Product hierarchy no. *				Part no.	SBU	Type / Description
SBU	PG	PUG	Type			
02	005	116	0000001168	See list below	Connectors	DD21 Power entry modules

2 Type of change

Product Change Notification					DD21 Power entry modules new approval		
owner	creation date	release date	released by	change order	rev	page	D10-101-985
sariogar	13.07.2026	13.07.2026	gassmael		B	1 of 2

Current product	Product with new approval

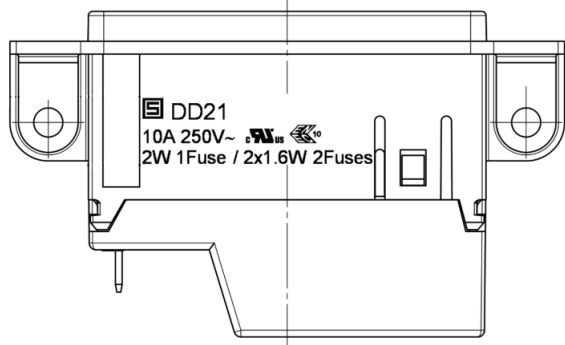
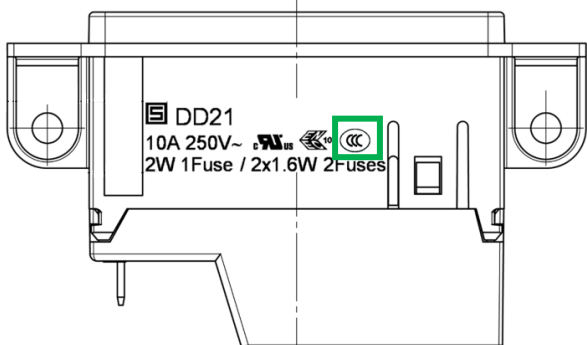
- DD21 new with CCC-Approval
- Packaging label new with all approvals

DD21 new with CCC-Approval.

Old packaging label	New packaging label

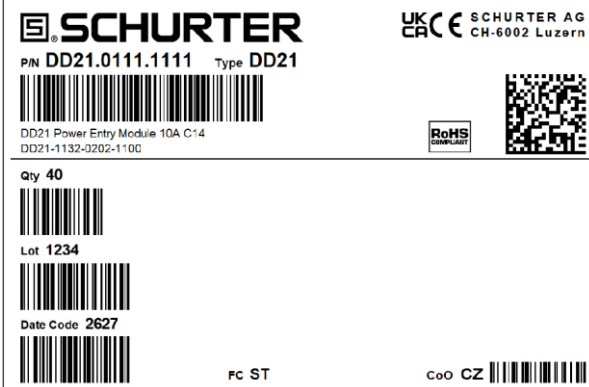
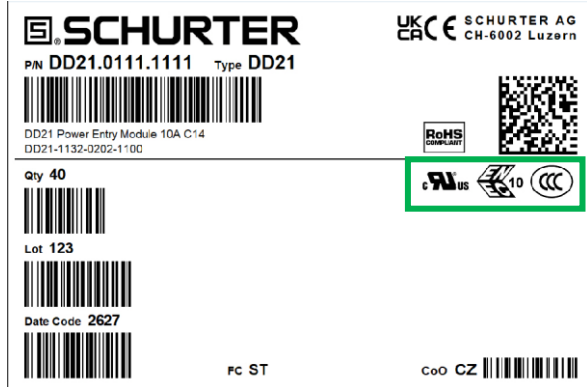
Packaging labels will be changed in week 29/2026 (Date code 2629 or higher on the label).
Markings on the product will be changed starting week 38/2026 (Date code 2629 or higher). Rollout will last approximately 6 months depending on the variant.
This change has no effect on the validity of the approval certificates.
